Project name: Case 24-04 & 24-05 Hudson Commercial Minor Subdivision and Site Plan

Review Number: 1

HUDSON COMMERICAL
FINAL SITE PLAN

Sheet Number: AS1.0

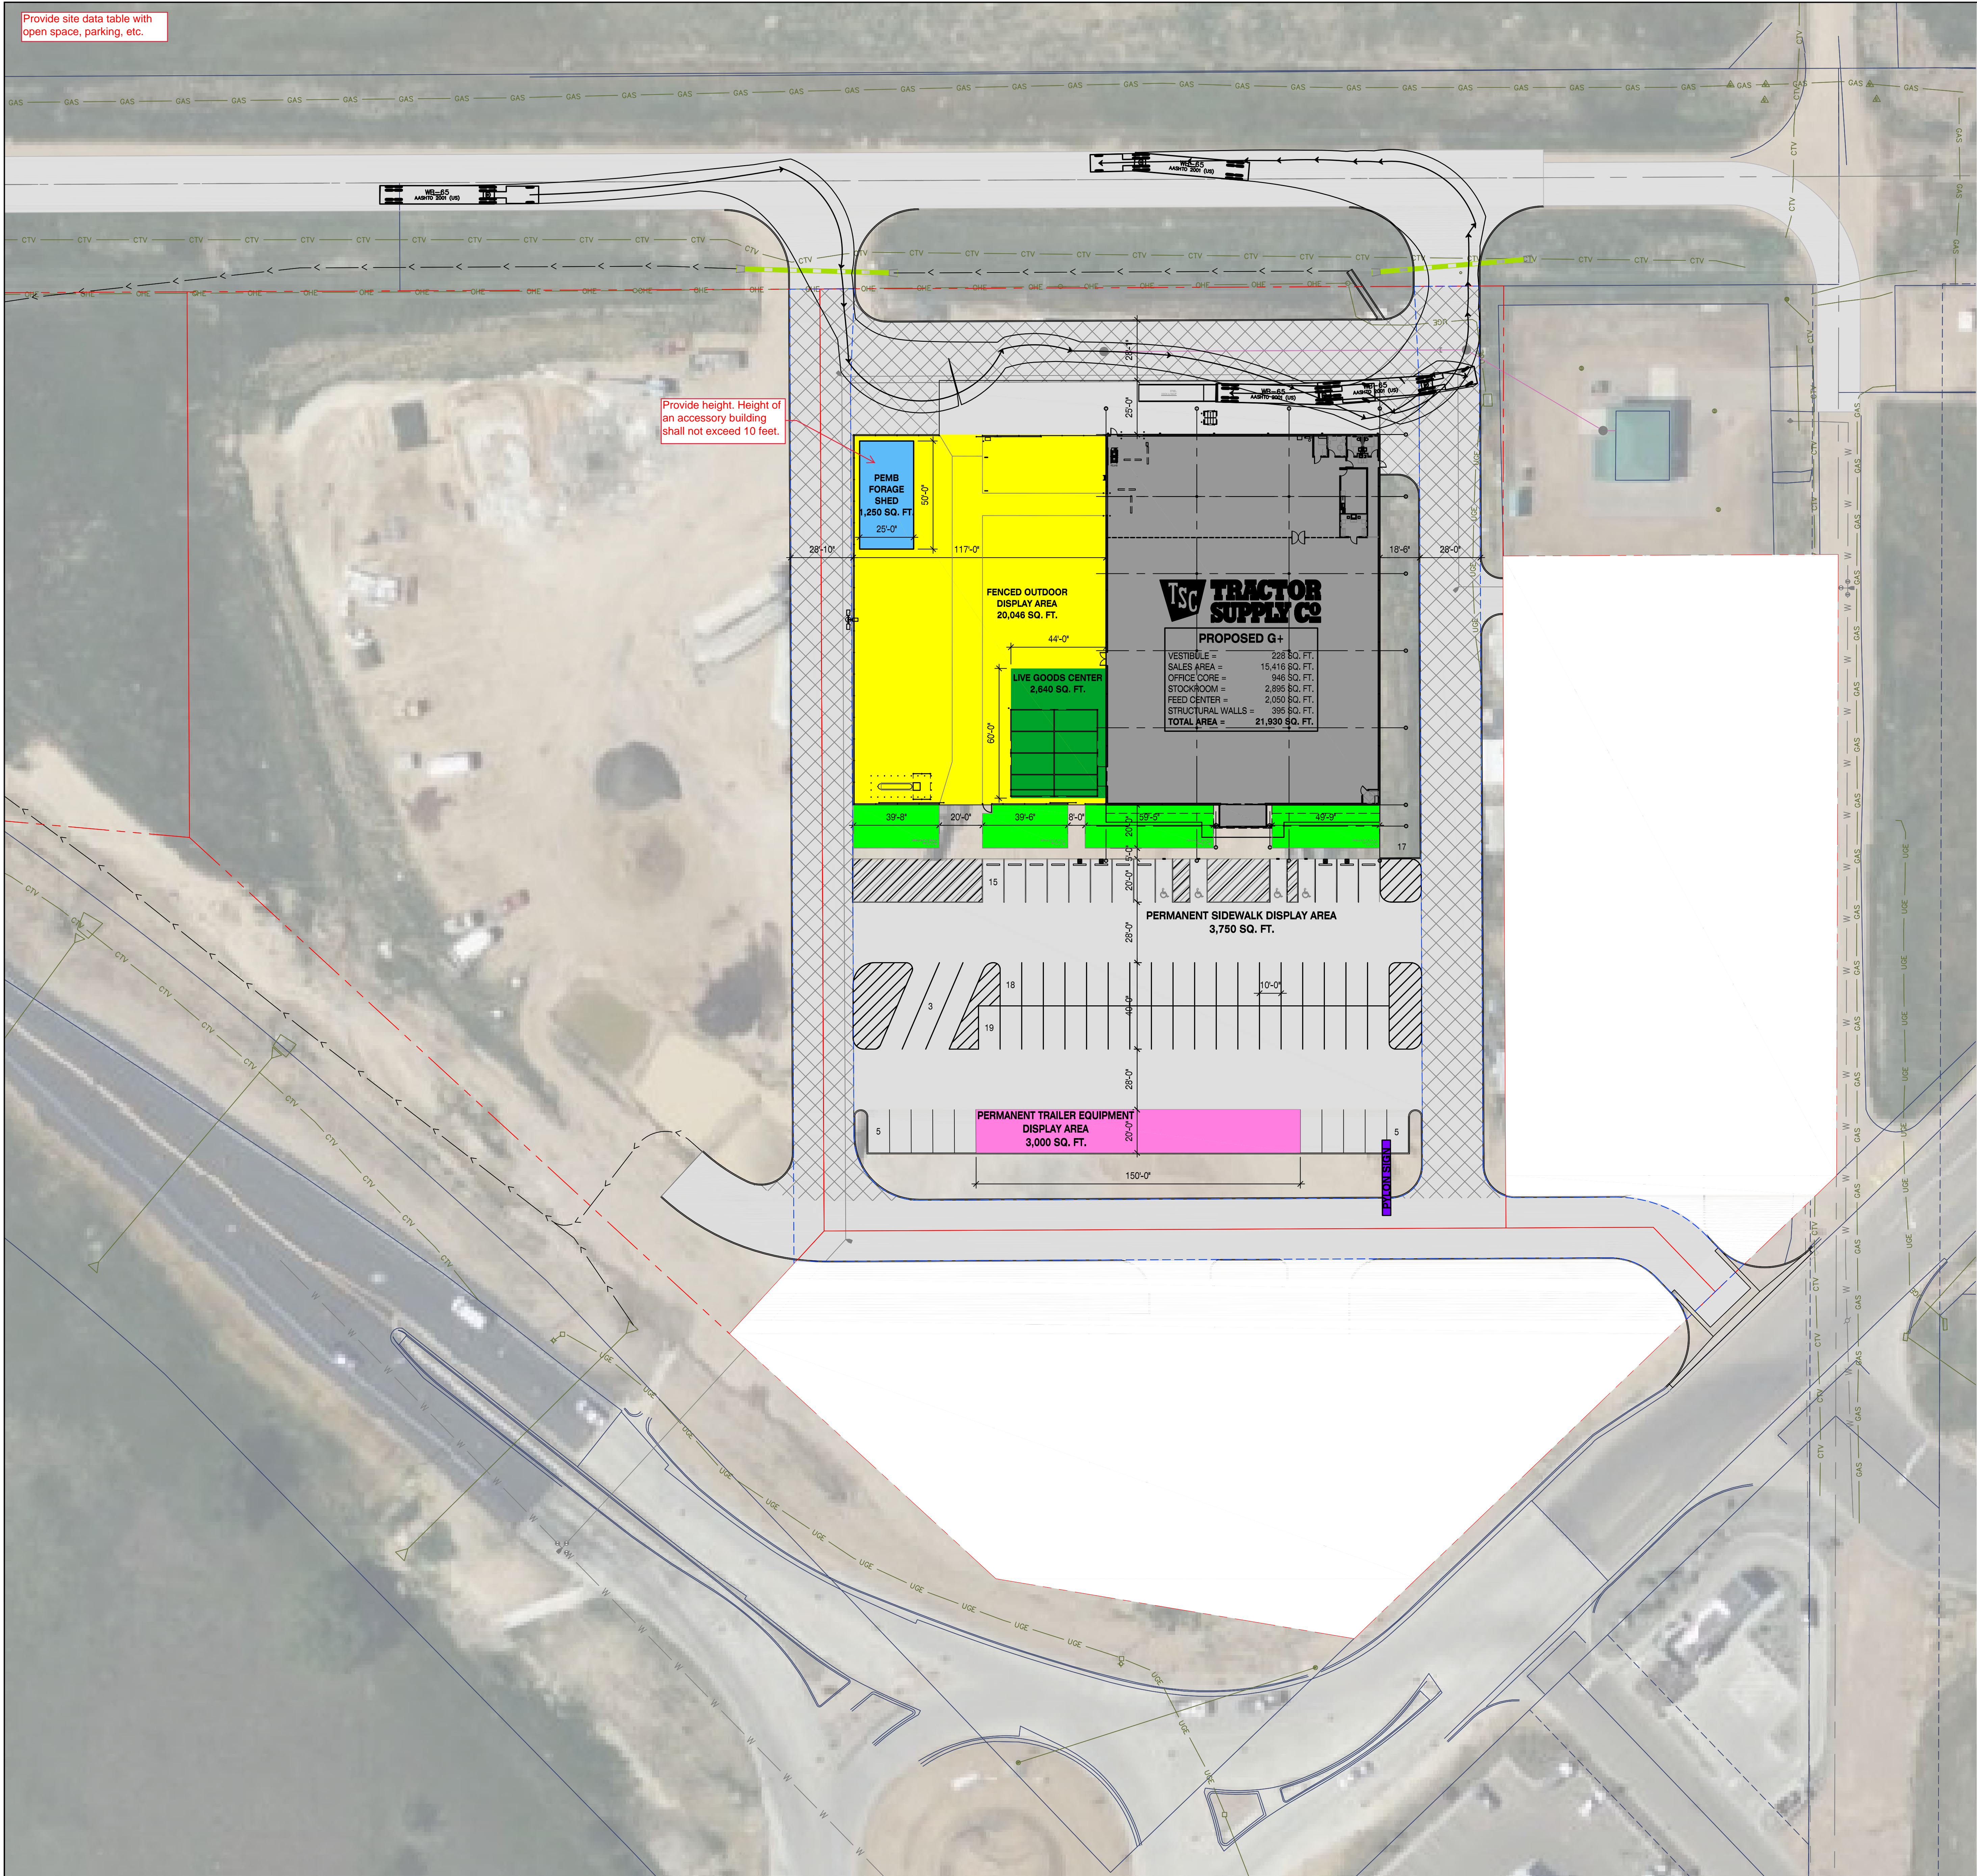
Provide site data table with open space, parking, etc.

Provide height. Height of an accessory building shall not exceed 10 feet.

Hudson Commerical		Site Plan	
Hudson, CO			
Final Site Plan			
Proj. Name:			
Location:			
Plan Set:			
Sheet Name:

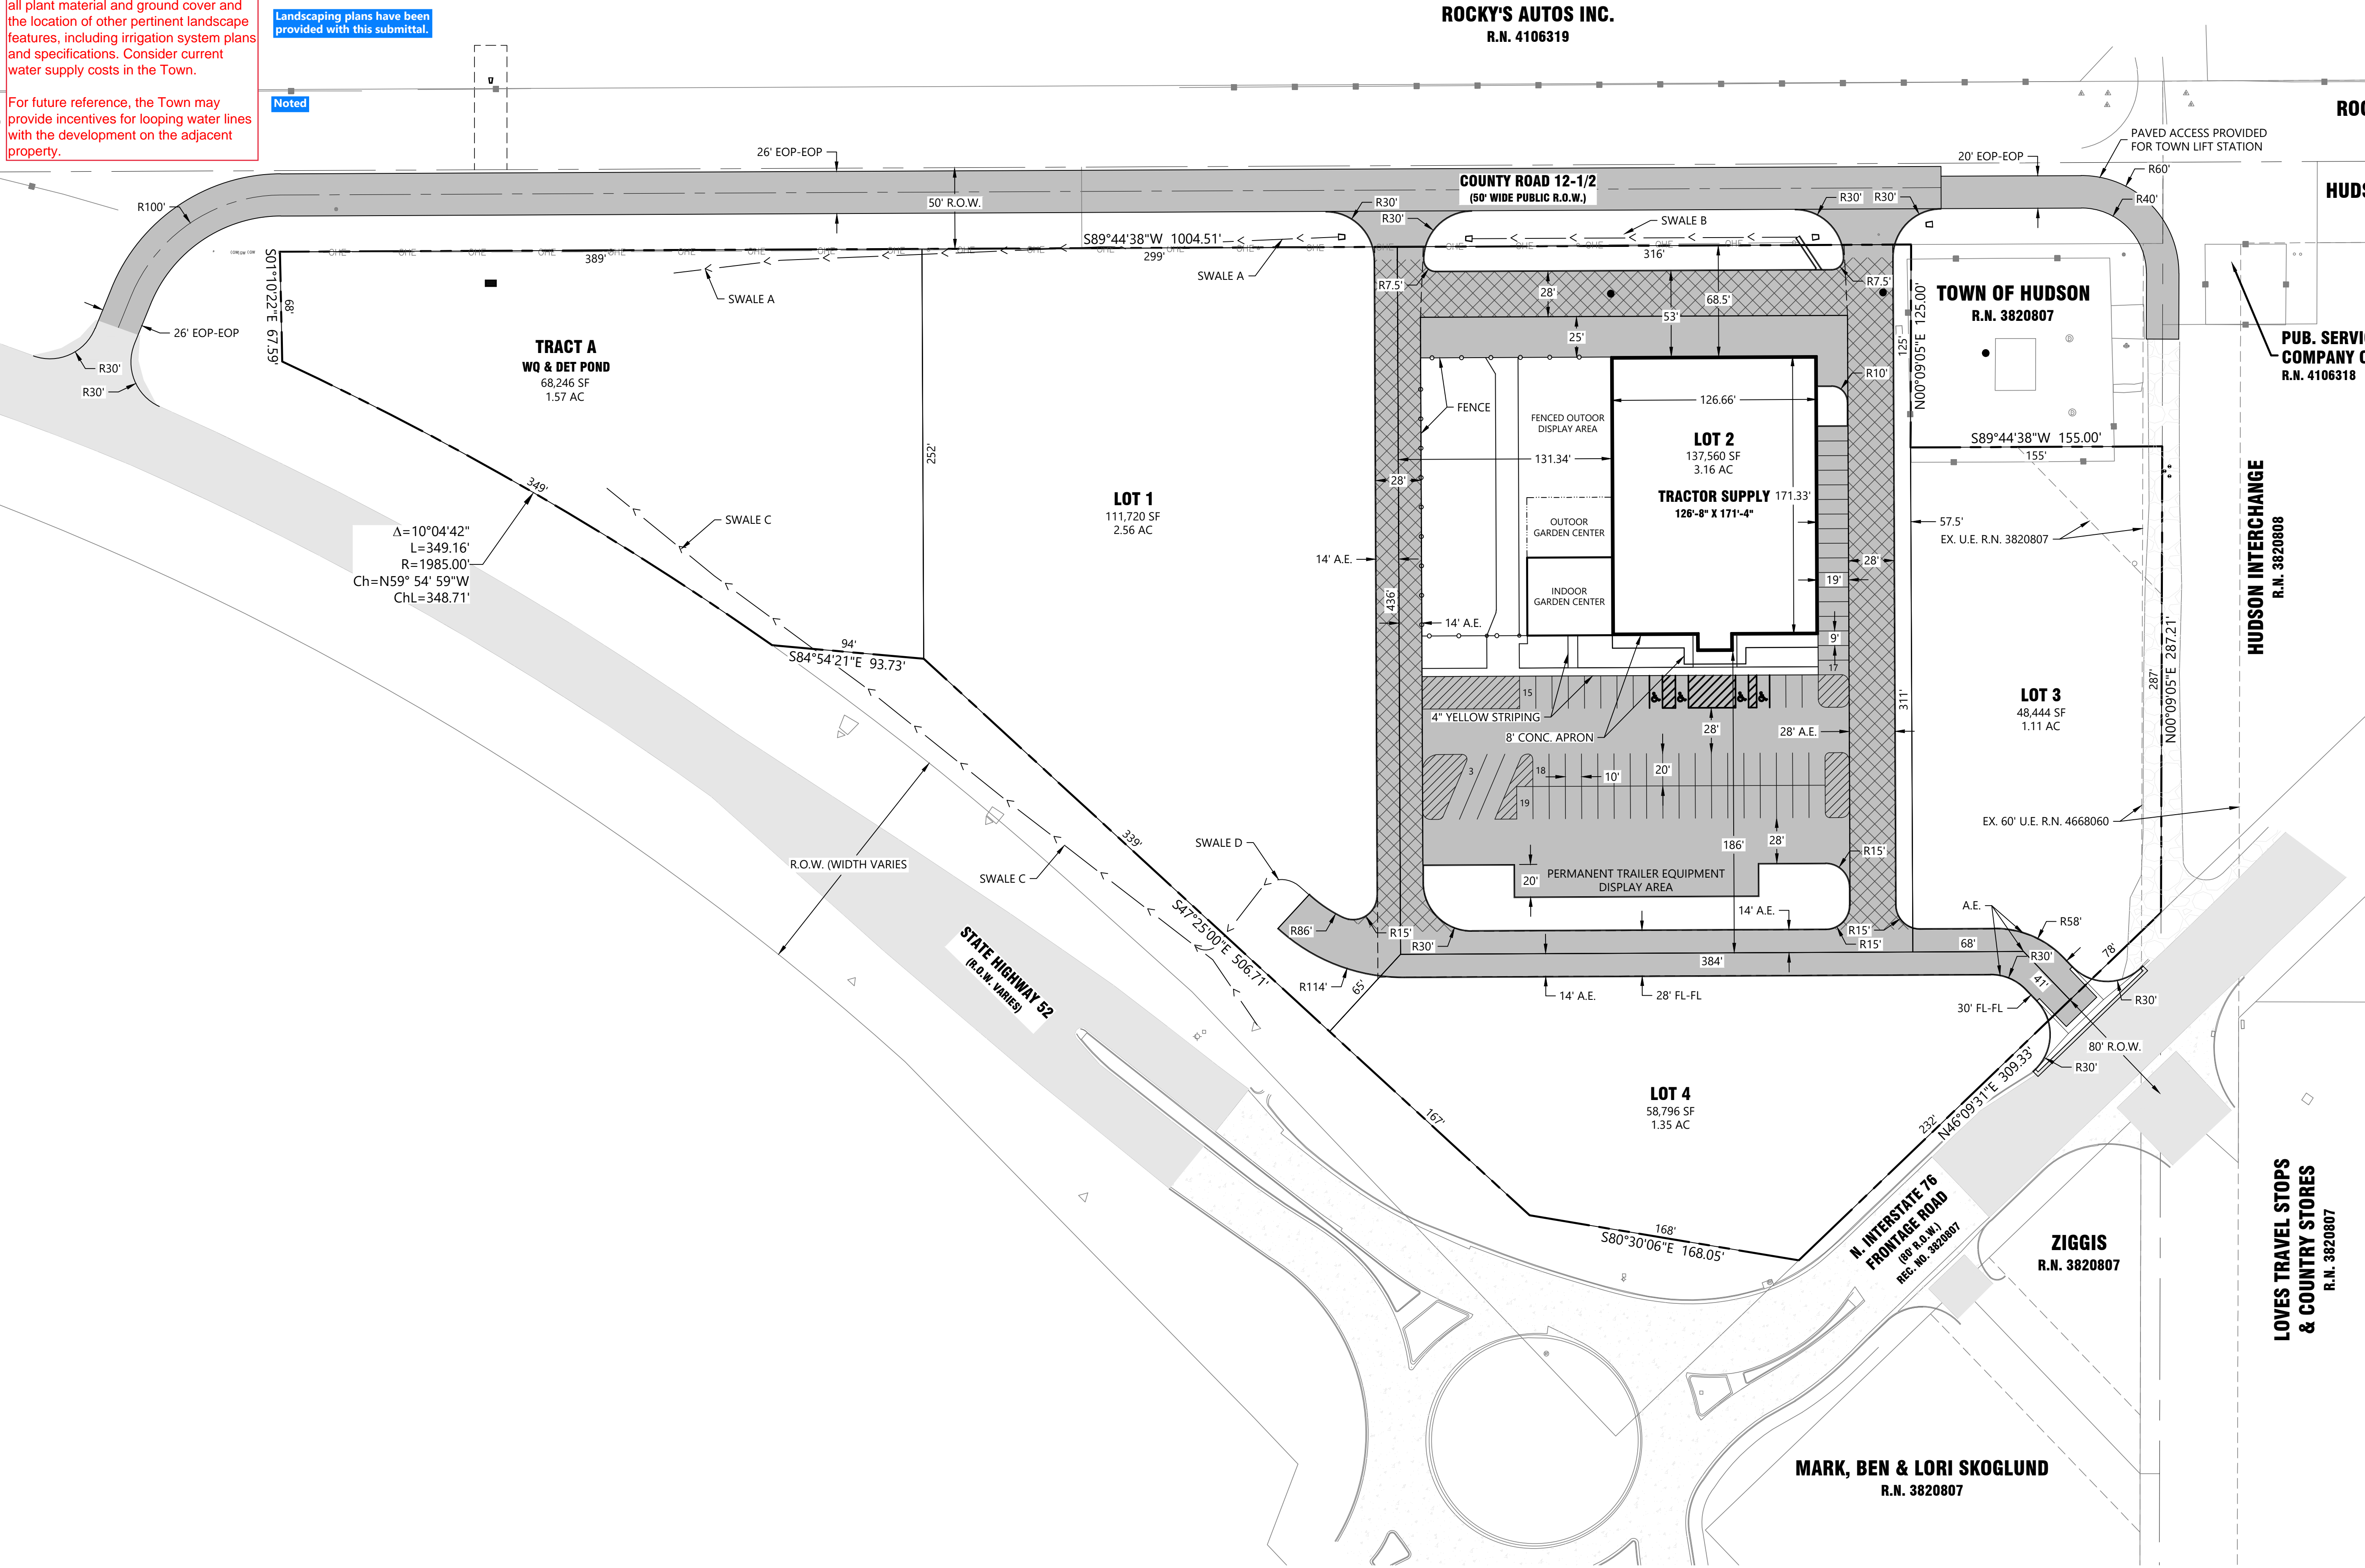
Provide a lighting plan with specifications on exterior lighting fixtures.

Provide the location and dimensions of landscaped areas, location and names of all plant material and ground cover and the location of other pertinent landscape features, including irrigation system plans and specifications. Consider current water supply costs in the Town.

For future reference, the Town may provide incentives for looping water lines with the development on the adjacent property.

Lighting and photometric plans have been provided.

Landscaping plans have been provided with this submittal.

Noted

HUDSON COMMERCIAL PLAT
LOCATED IN THE SOUTHWEST 1/4, SECTION 3, TOWNSHIP 1 NORTH, RANGE 65 WEST OF THE SIXTH PRINCIPAL MERIDIAN
TOWN OF HUDSON, COUNTY OF WELD, STATE OF COLORADO

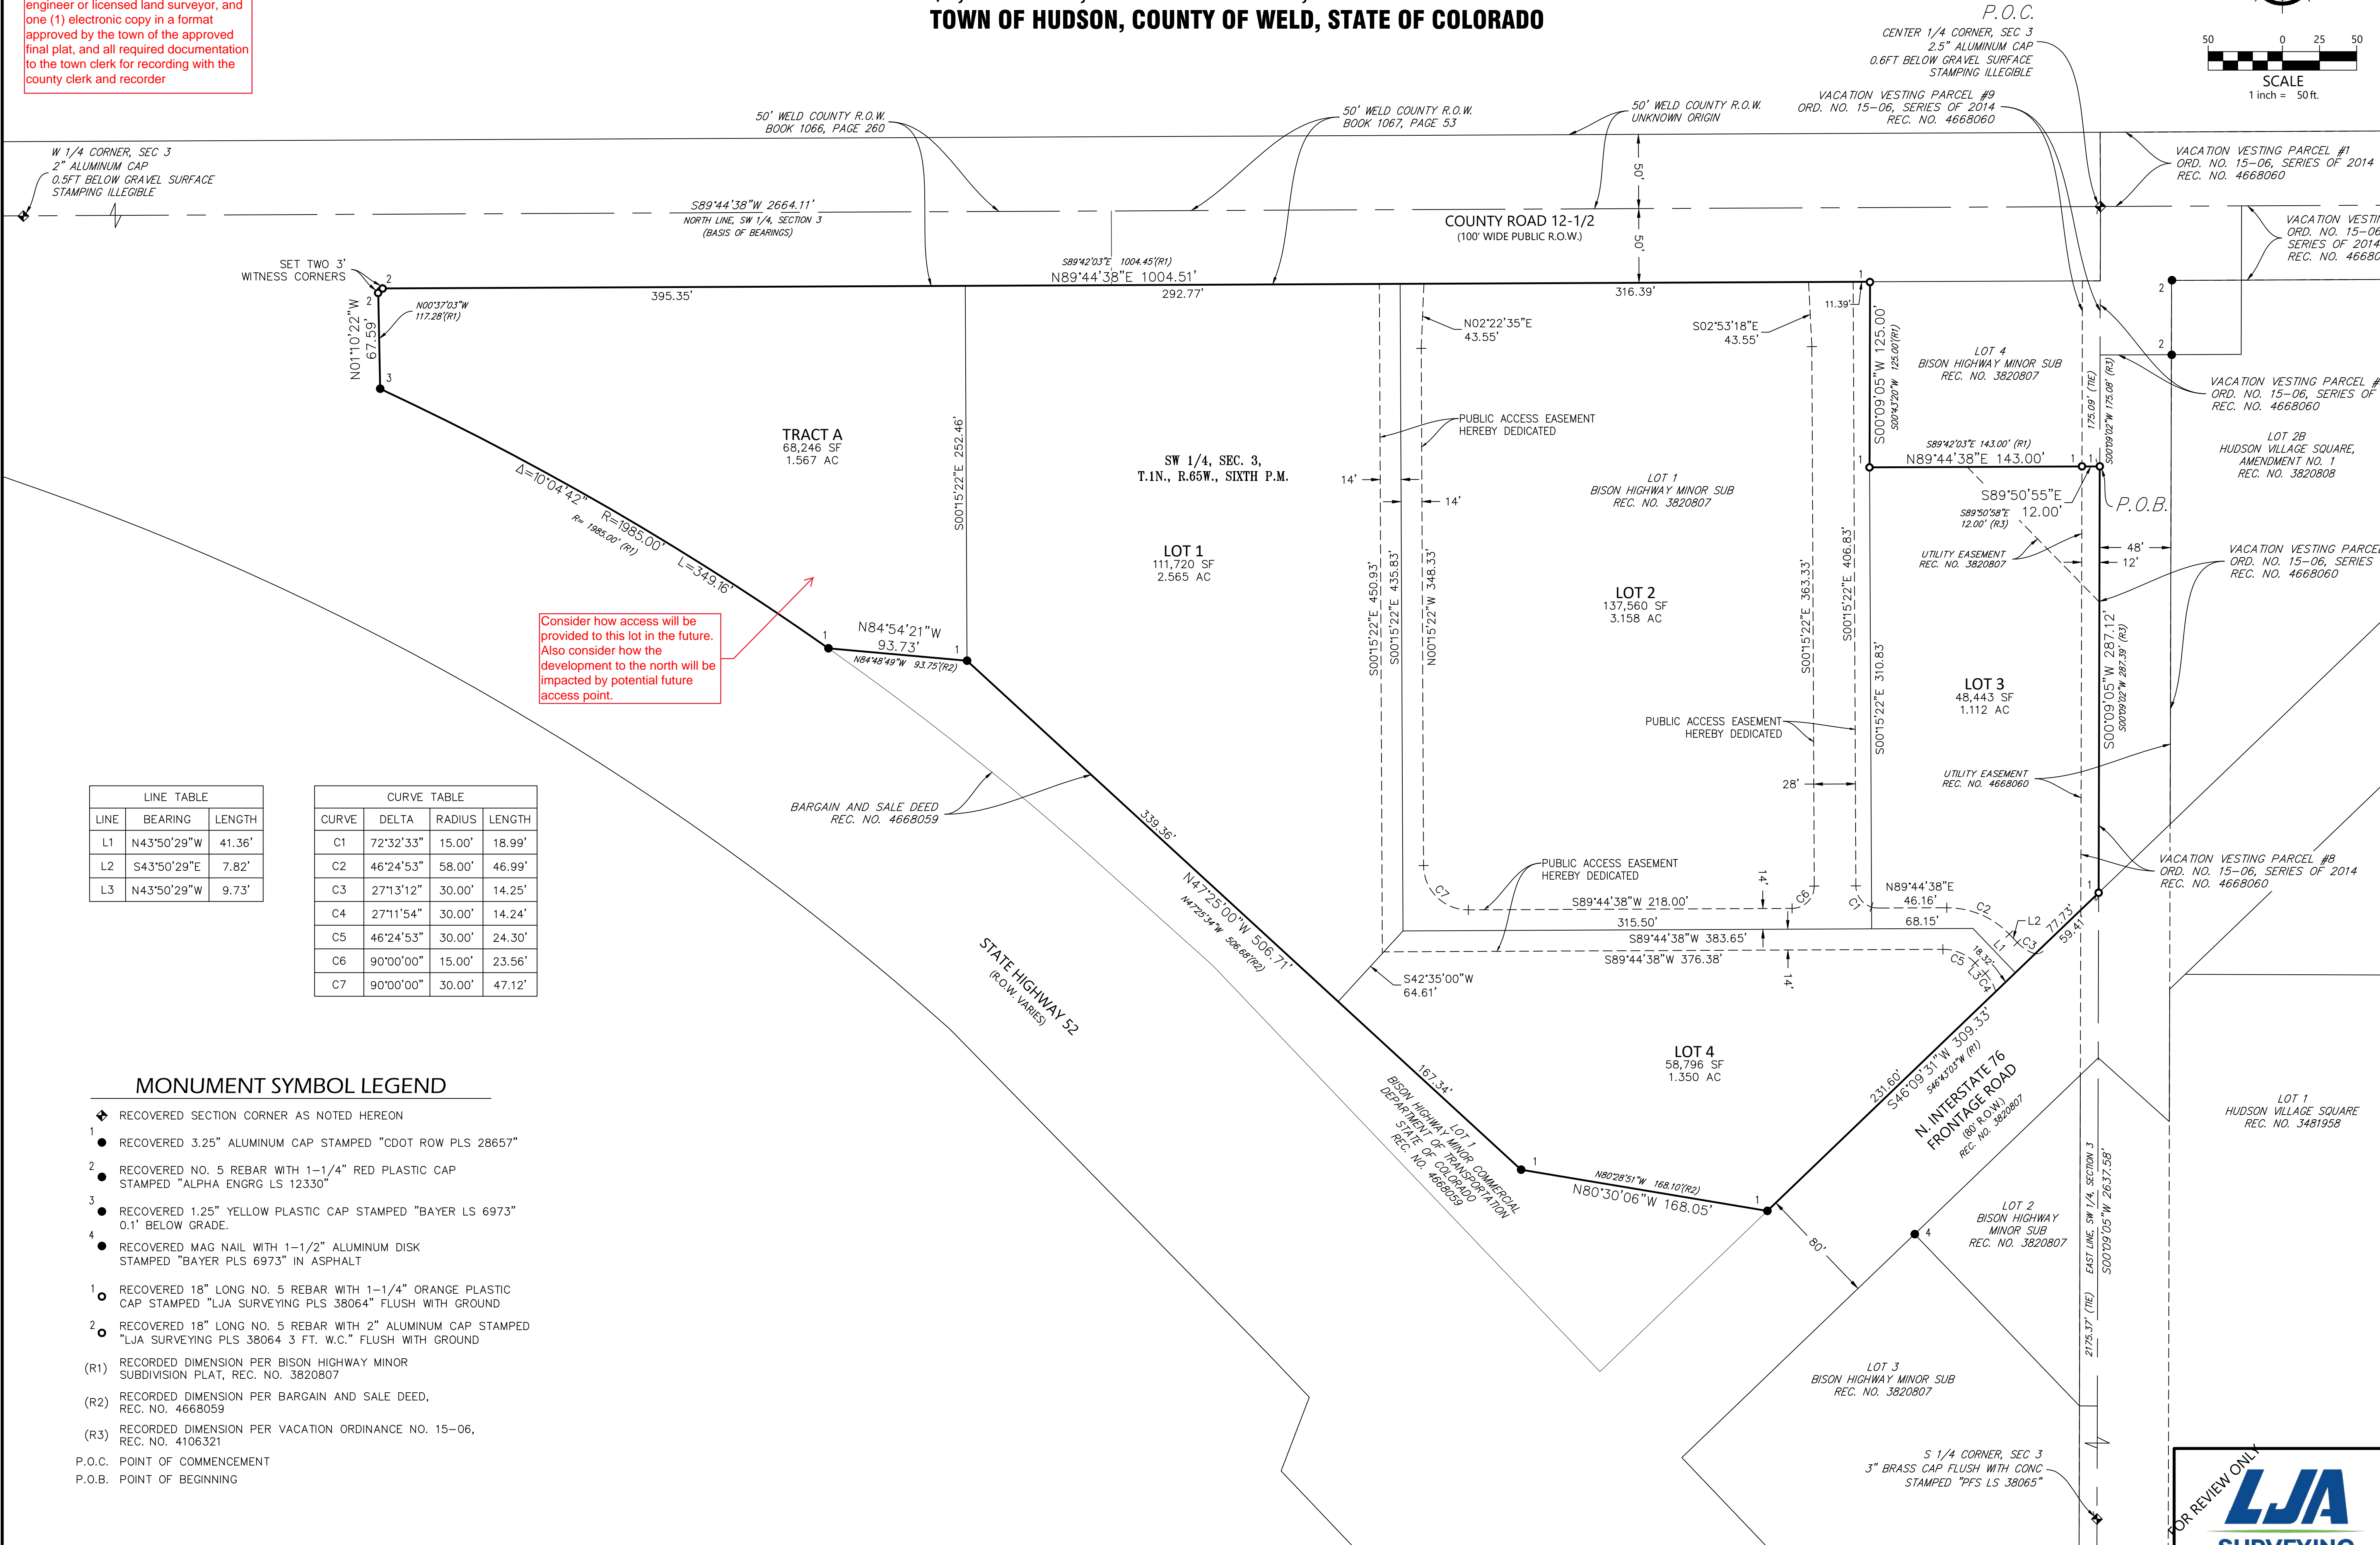
FYI: Within fourteen (14) days of approval of the final plat by the town council, the applicant shall submit two (2) 24" x 36" Mylar originals, signed by the owner and by a licensed professional engineer or licensed land surveyor, and one (1) electronic copy in a format approved by the town of the approved final plat, and all required documentation to the town clerk for recording with the county clerk and recorder
